**re: Grading and Servicing Plan Review**  
Proposed Multi-Storey Building  
4836 Bank Street - Ottawa, Ontario

**file:** PG2934-MEMO.03

- ☐ General Plan of Services – Seniors Apartments – Bank Street at Dun Skipper Drive – Project No.148290 – Sheet No.C-001– Revision 2 dated February 18, 2025.
- ☐ Grading Plan – Seniors Apartments – Bank Street at Dun Skipper Drive – Project No.148290 – Sheet No.C-200– Revision 1 dated February 18, 2025.

### Figure 1: Site Servicing Insulation Plan

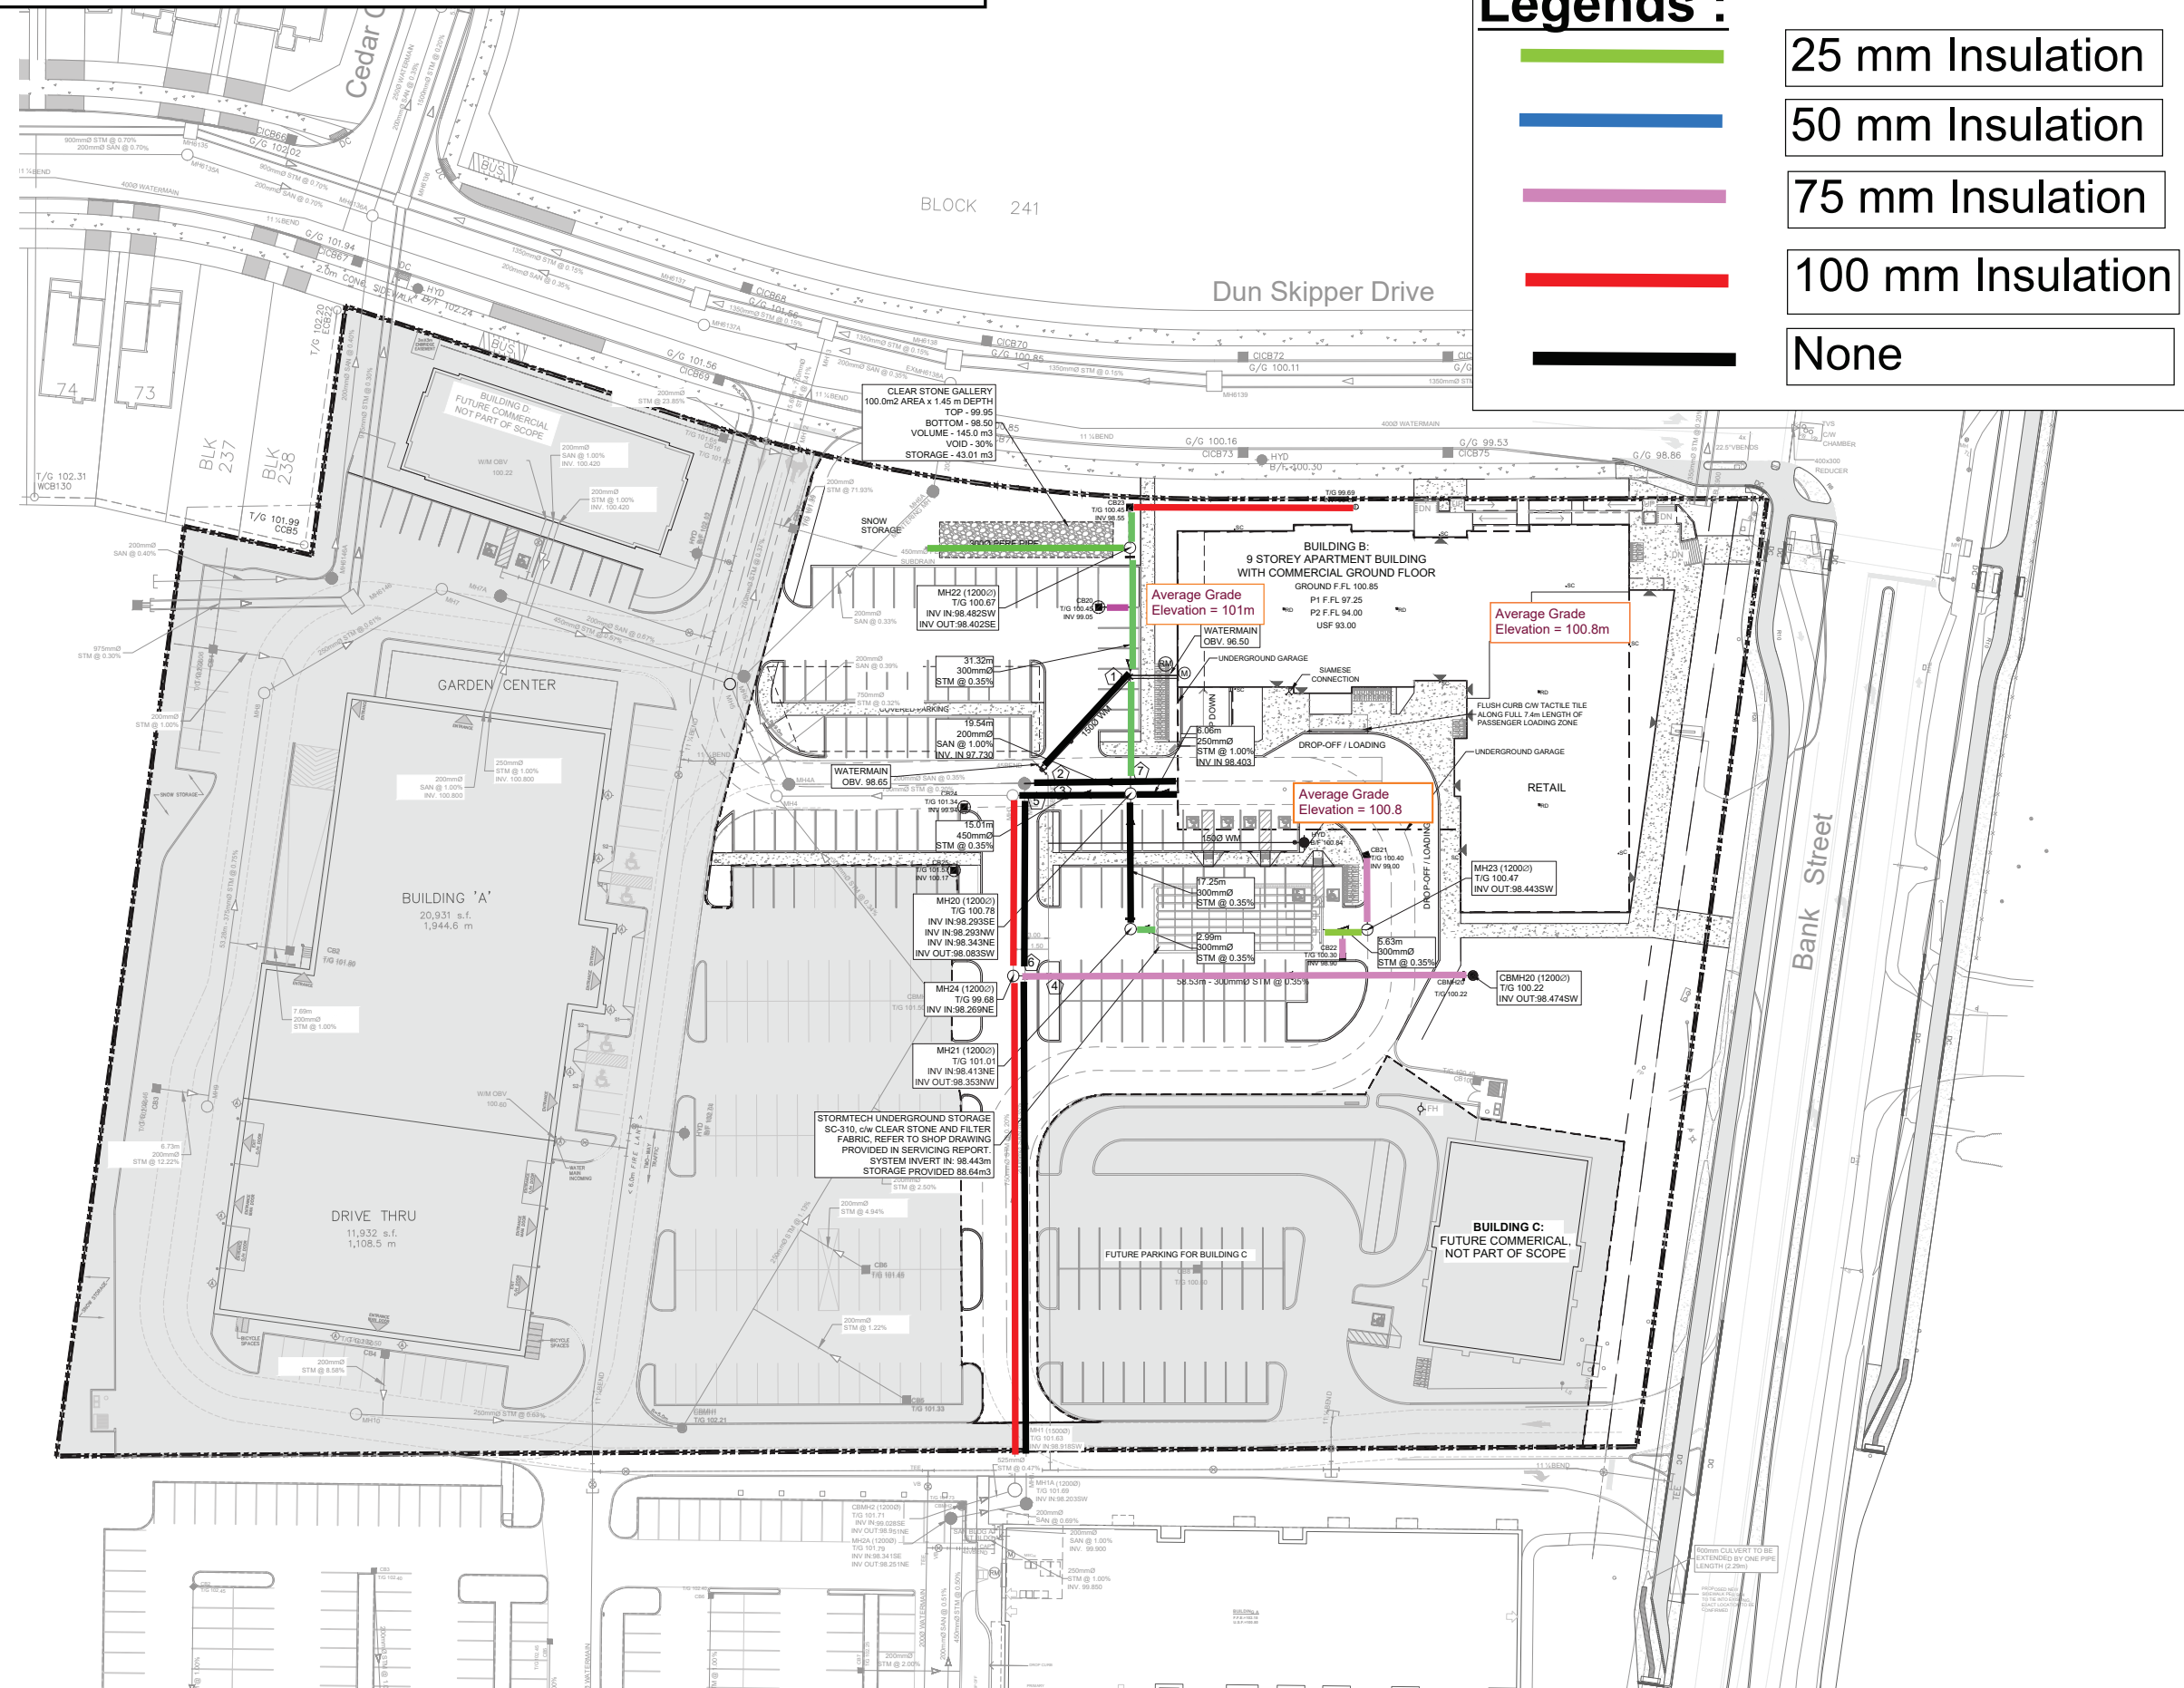
Any portion of the services installed at a depth of 2.0 m or deeper below finished grade for sewers, or 2.4 m or deeper below finished grade for watermains, is considered to have sufficient soil cover for frost protection.

However, there are sections of the site servicing, which are located within the frost zone. The sections of pipe and the required insulations thickness are highlighted on attached Figure 1- Site Servicing Insulation Plan. Where insufficient soil cover is present above the obvert of the pipe, the following frost protection criteria on the next page should be followed:

<b>Table 1 - Rigid Insulation Recommendations for Sewer Pipes with Reduced Soil Cover</b>			
<b>Thermal Condition</b>	<b>Soil Cover Provided (mm)</b>	<b>Insulation Dimensions</b>	
		<b>Thickness (mm)</b>	<b>Extension (mm)</b>
Unheated	600 to 1,000	100	Boxed on 3 sides or overtop and extending 2000 mm horizontally beyond edge face of the sewer
	1,100 to 1,400	75	Boxed on 3 sides or overtop and extending 900 mm horizontally beyond edge face of the sewer
	1,400 to 1,700	50	Boxed on 3 sides or overtop and extend 600 mm horizontally beyond edge face of the sewer
	1,700 to 2,000	25	Boxed on 3 sides or overtop and extend 300 mm horizontally beyond edge face of the sewer
<b>Notes:</b> All designs are based on a freezing index of 1000°C-days

Table 2 - Rigid Insulation Recommendations for Water Service Pipes with Reduced Soil Cover			
Water Pipe	Soil Cover Provided (mm)	Insulation Dimensions	
		Thickness (mm)	Extension (mm)
Watermain	2000 to <2400	50	Boxed or overtop and extending 500 mm horizontally beyond edge face of the water pipe
		Pipe Insulation Details	
Water Service Laterals	1800 to <2400	150 mm thick Foamular XPS Pipe Insulation	
Notes: All designs are based on a freezing index of 1000°C-days

All rigid insulation should consist of either Dow Chemical High-Load 40 (HI-40), Styro Rail SR.P400, or equivalent which is approved by Paterson. The placement of all insulation within the service trenches must be reviewed and approved by Paterson personnel at the time of construction.
